Our Reference: 41901-04 [ID 1014252]
Council Reference: OPW/2024/523

Re: Response to Information Request for Development Application over Lots 188 and 189 RP173728 at 79 Courtney Drive, Upper Coomera

On behalf of our Client *HB Land Qld Pty Ltd* we make the following response to Council's Information Request, dated 4 June 2024 for the Development Application as allowed by s13.2 and s 13.3 of the Development Assessment Rules for the *Planning Act (2016)*.

DRIVEWAY GRADING PLAN

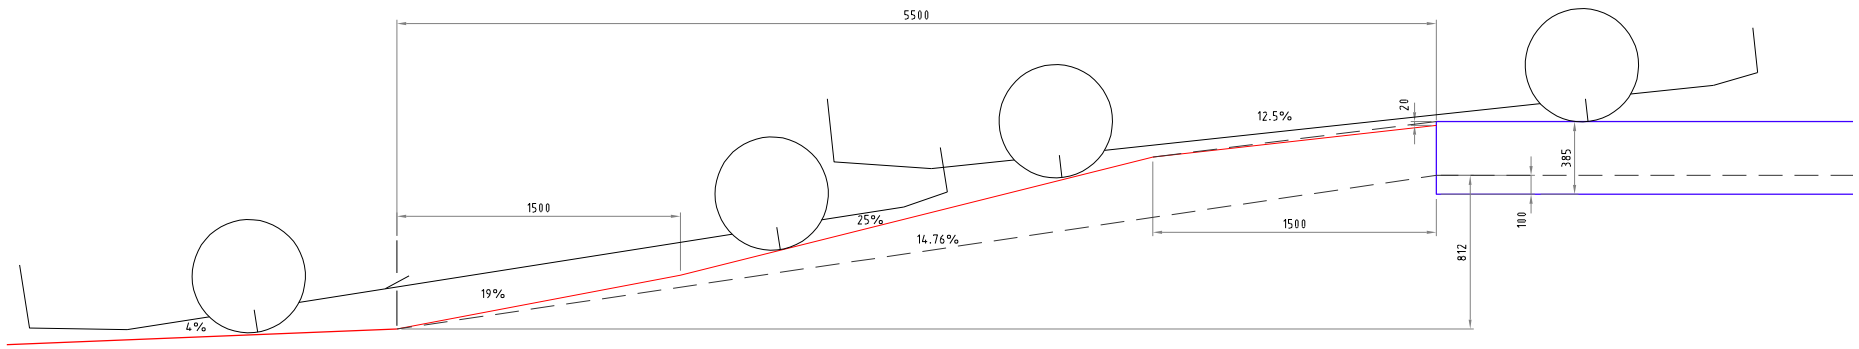
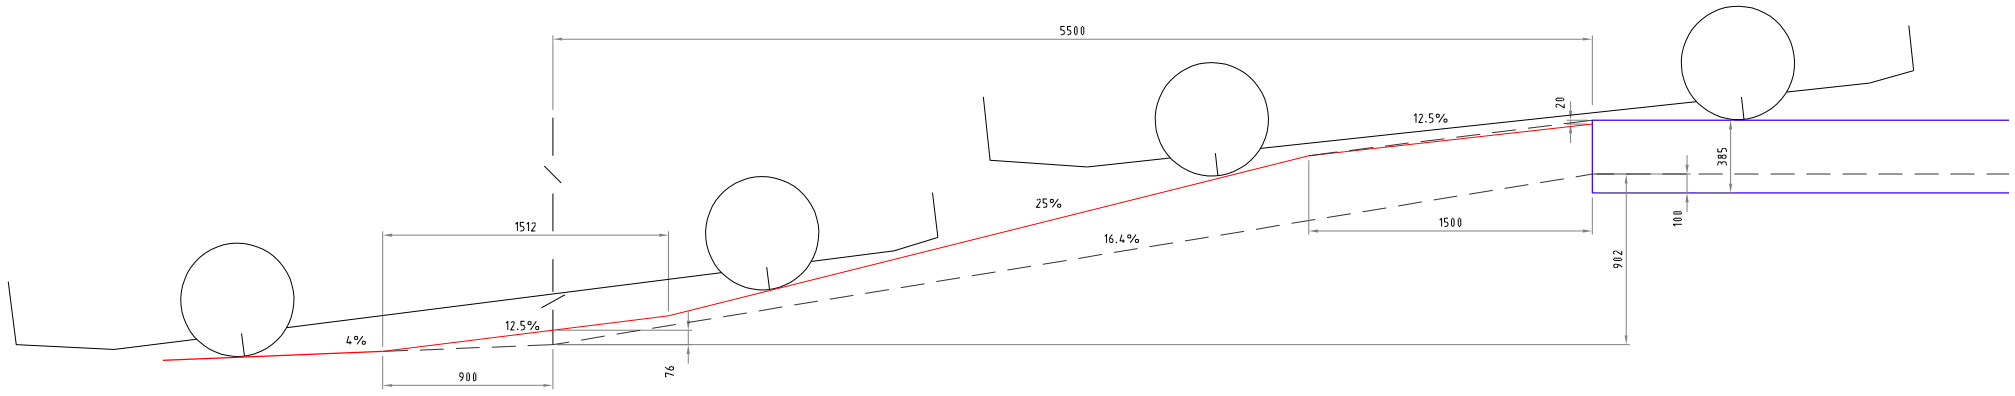
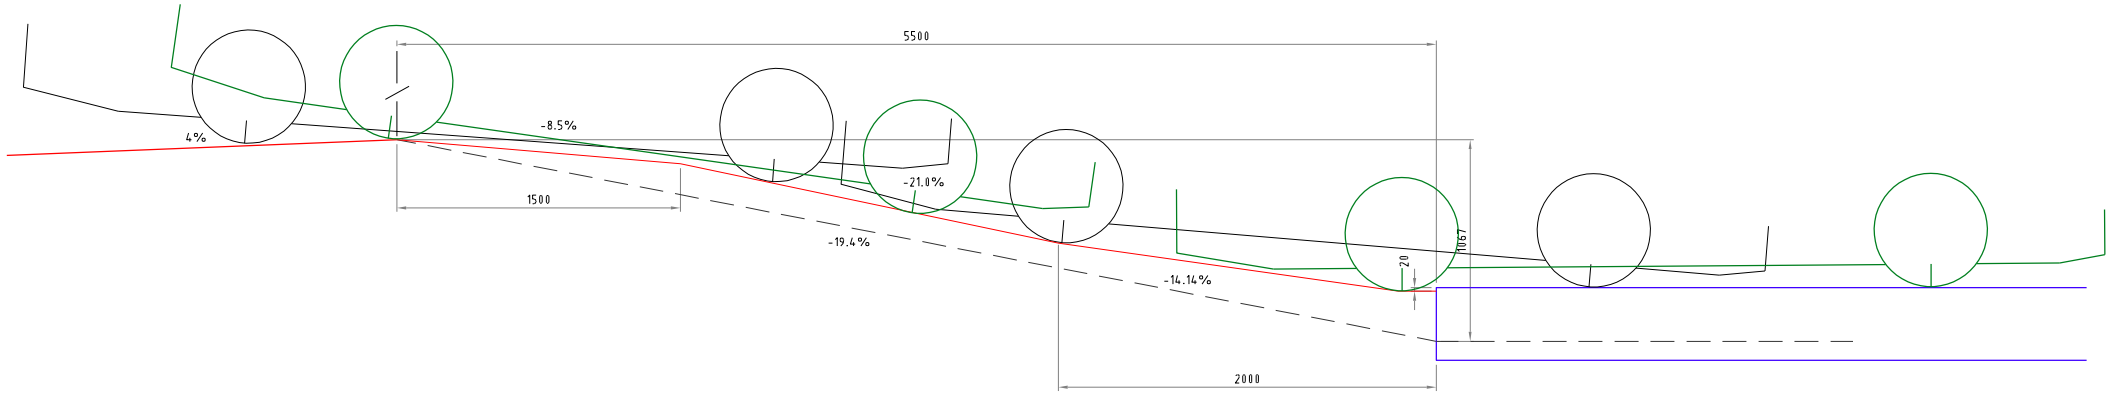
Item 2 Earthworks for Driveway Access

As per Condition No. 32 of COM/2019/82, the applicant needs to design and construction earthworks for Lot No. 226, 243 and 248 to achieve driveway access grades. The construction of earthworks must comply with the below requirements and drawings listed below:

i The maximum gradient of the earthworks in the 5.5 metre setback areas for access to the lots listed above must not exceed the grades shown on the above listed drawings.

ii The earthworks must provide a minimum 4.0m wide formation area (to allow a 3.0 driveway) for access and must align with the proposed VXO location for the lots listed above, as shown on the above listed drawings.

Please see attached Drawings 41901-ALL-SK004 and 41901-ALL-SK005 **(Attachment 1)**, this condition relates to 3 lots (226, 243 and 248) we note that these were addressed during the ROL approval process and have not been changed.

RETAINING WALL
AND DETAIL GRADING PLAN
SHEET 01

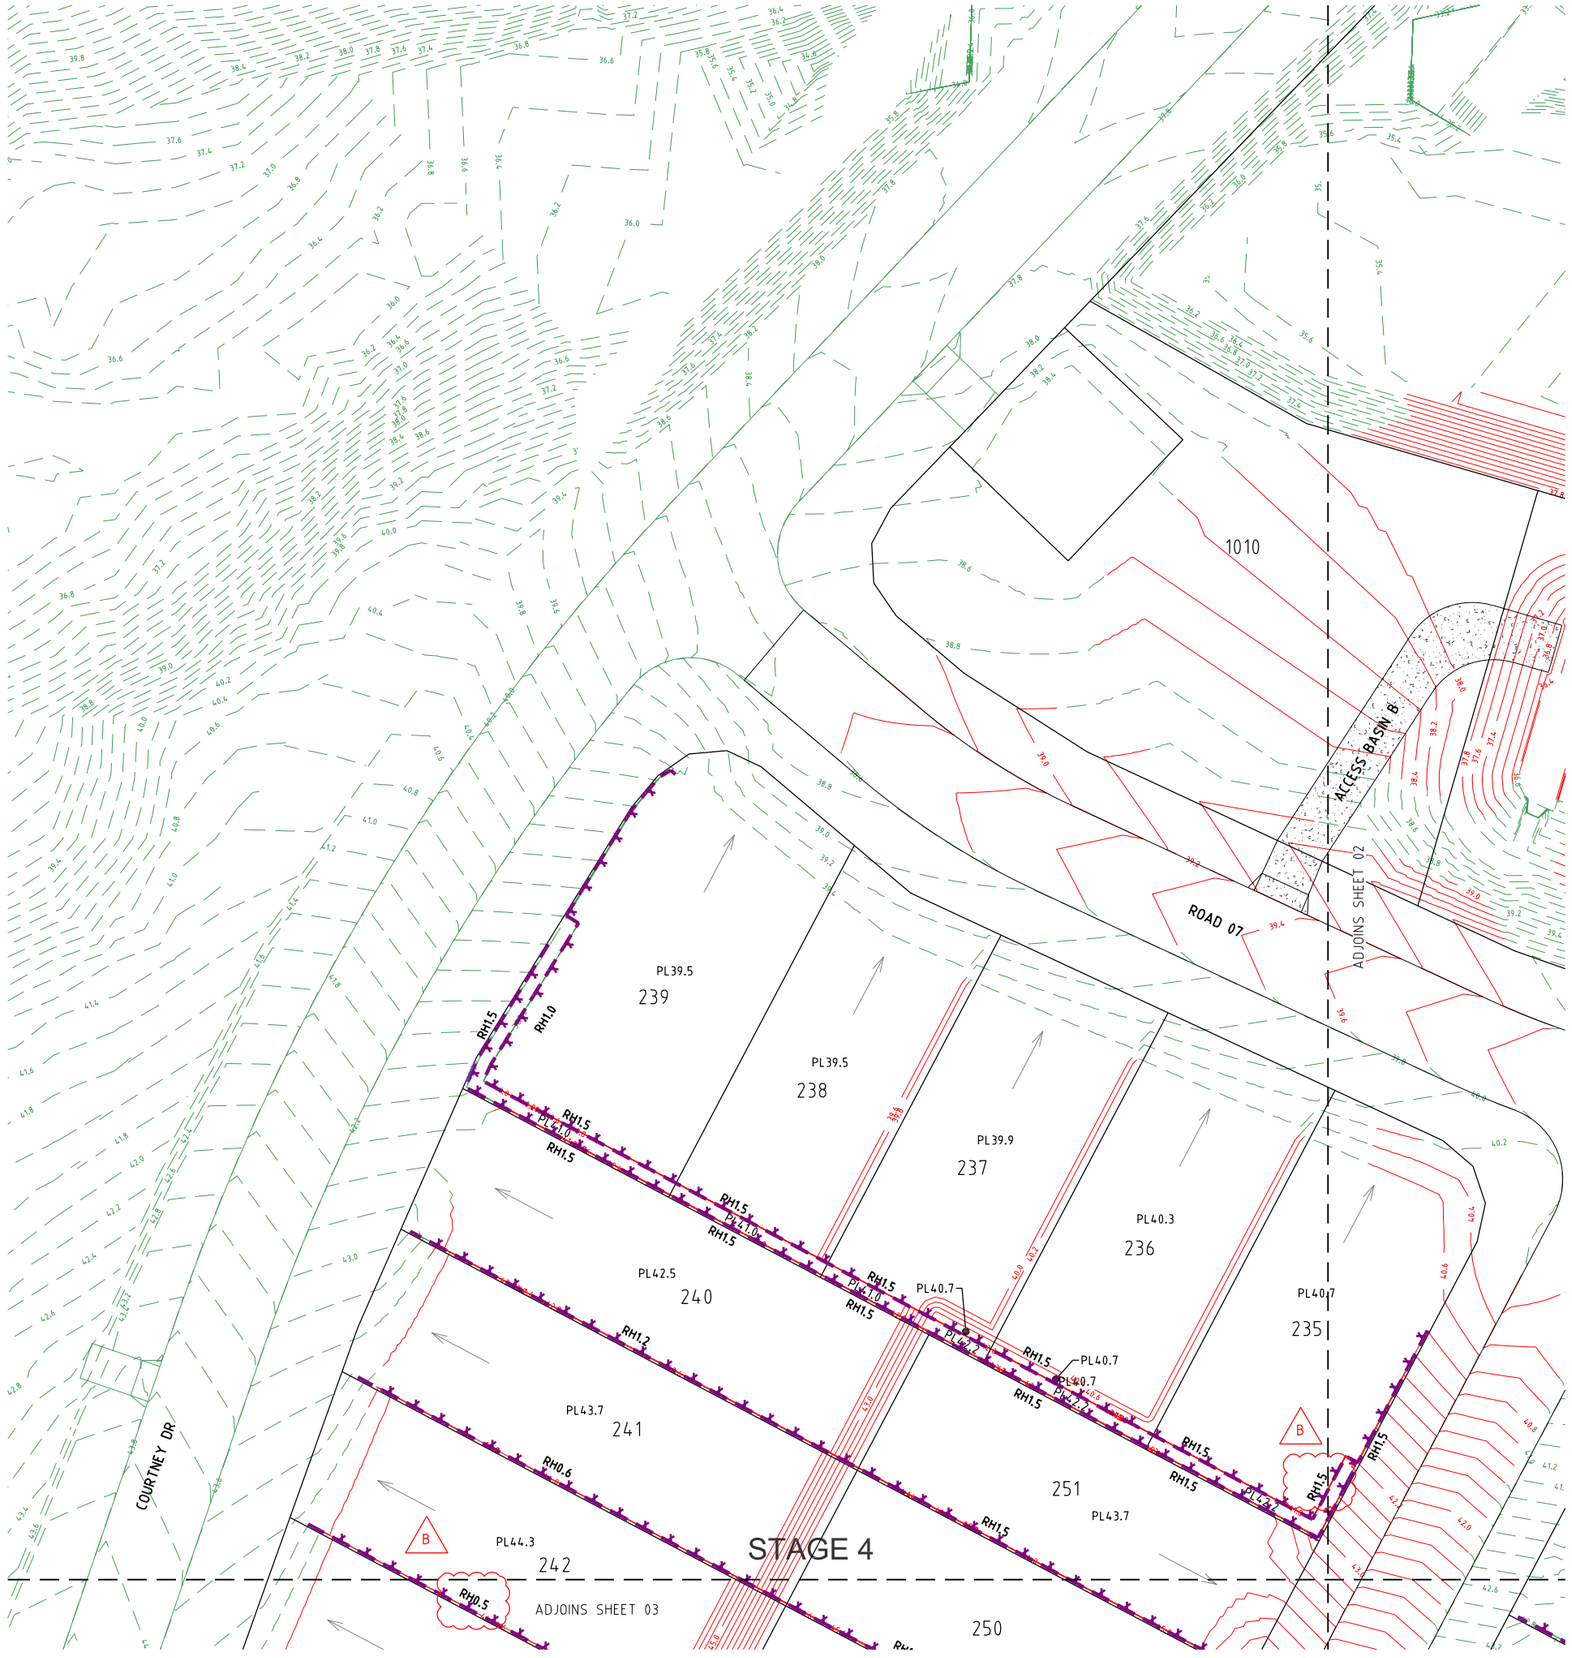
Item 1 Retaining Wall Heights

The applicant is requested to demonstrate that the proposed retaining wall heights comply with Condition No. 22 of COM/2019/82.

We have reviewed this plan and can confirm that it complies with the heights, we note that there were a couple of heights missing from our plan and we have added some additional heights. Please see attached updated plans 41901-04-060 Rev B to 062 Rev B for your approval.

INTERSECTION
GRADING DETAILS
SHEET 01

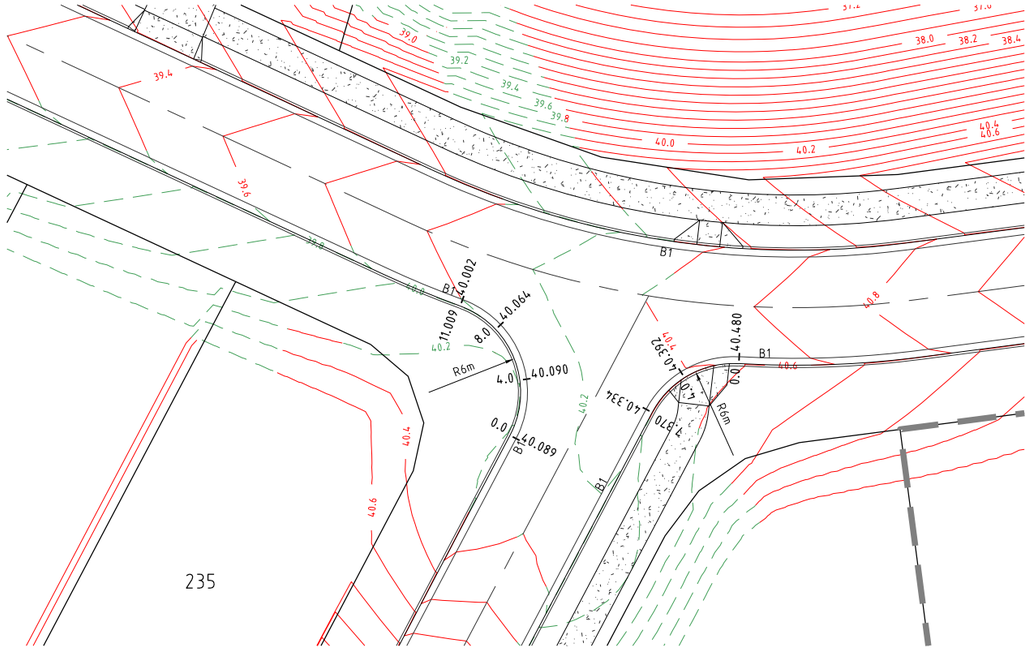
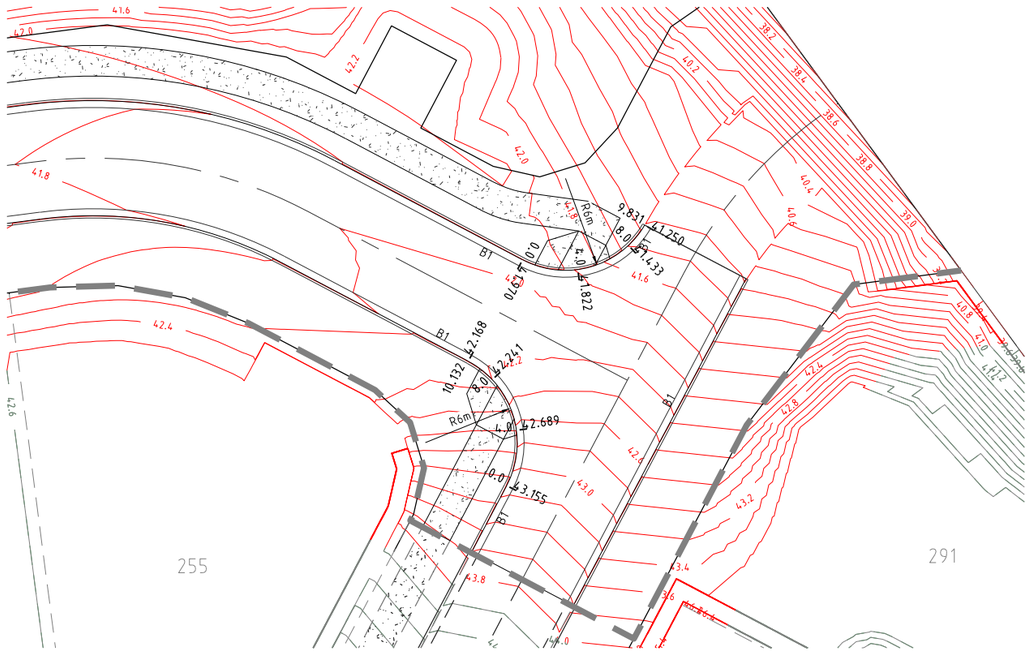
Item 3 Kerb Returns

Kerb returns at all standard residential access and collector street intersections are required to have a 6 metre maximum radius. The applicant is requested to demonstrate that this requirement has been complied with.

Please refer to drawing updated plans 41901-04-400 Rev A which show the kerb returns of 6m, all other intersections have been approved as part of the Stage 2 works (OPW/2024/1202).

LINEMARKING & SIGNAGE PLAN
SHEET 01

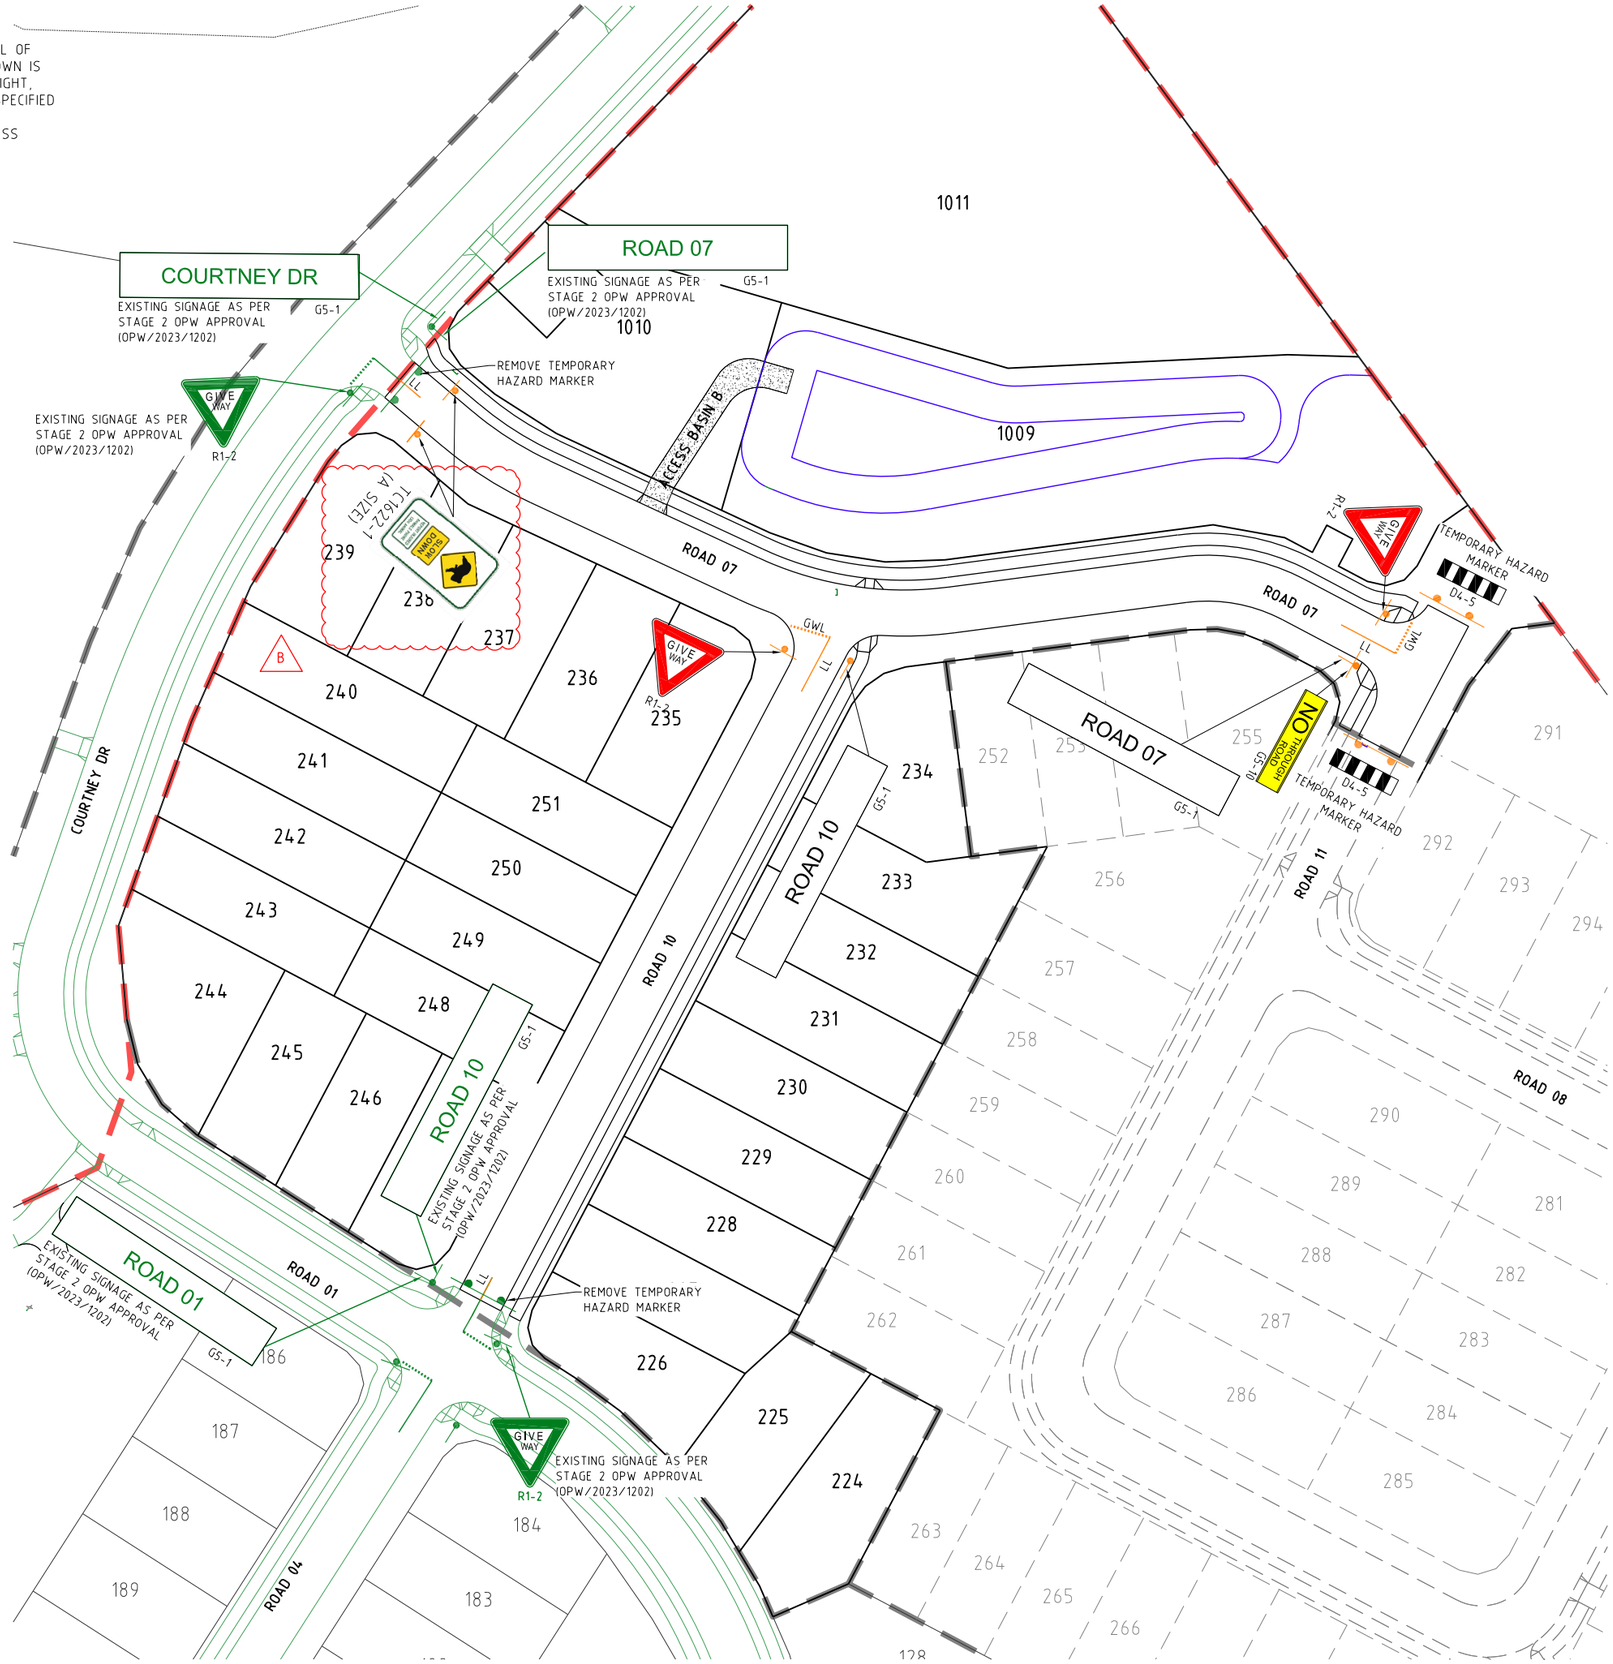
3. *The two proposed wildlife signs are quite a lot here – these size in B-size are 1400mm wide and 2.4m in height. I understand wildlife signage was conditioned as part of these approvals, but perhaps in a low-speed urban environment we can either remove one of these, or at the very least reduce these to the smaller A-size.*

Drawing 41901-04-420 Rev B has been updated to reflect a size A signage. As noted all other signage remains the same.

MH12/7 DETAIL IF PUMP STATION IS OPPERATIONAL

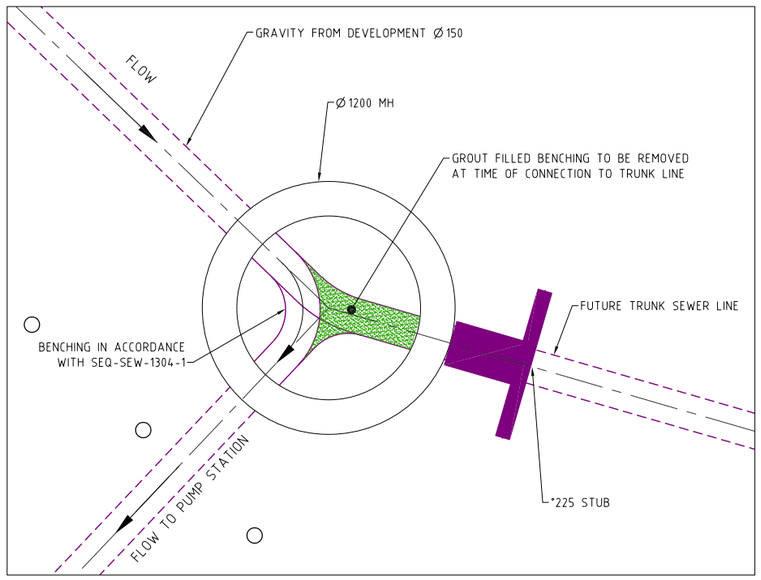
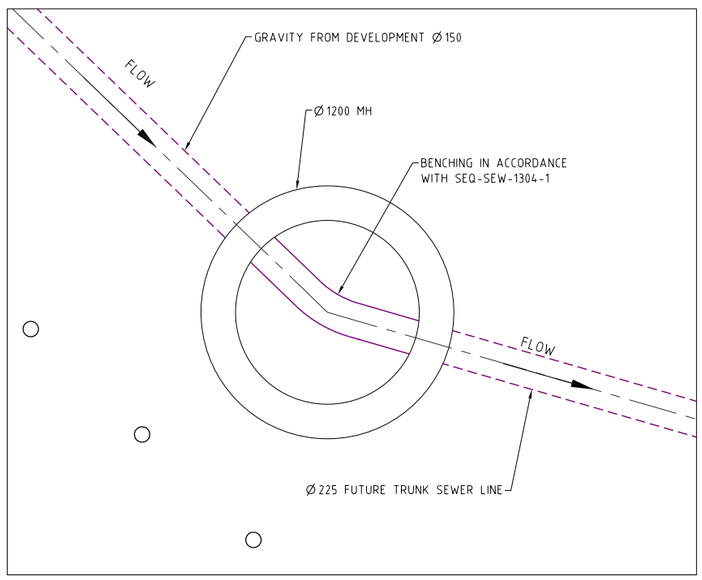
b. *The Sewer reticulation profiles drawing '41901-04-530', sheet 01, Revision A notes that custom benching is required for sewer structure 12/07 (1200mm dia. MH). Provide to Council a detail demonstrating the custom benching, ensuring consistency with SEQ-SEW-1304-1.*

Please refer to Drawing No 41901-04-510 Rev B showing a detail of this benching in accordance with SEQ-SEW-1304-1. We have included an option for if the pumpstation is operational and one option if the pump station is not operational.
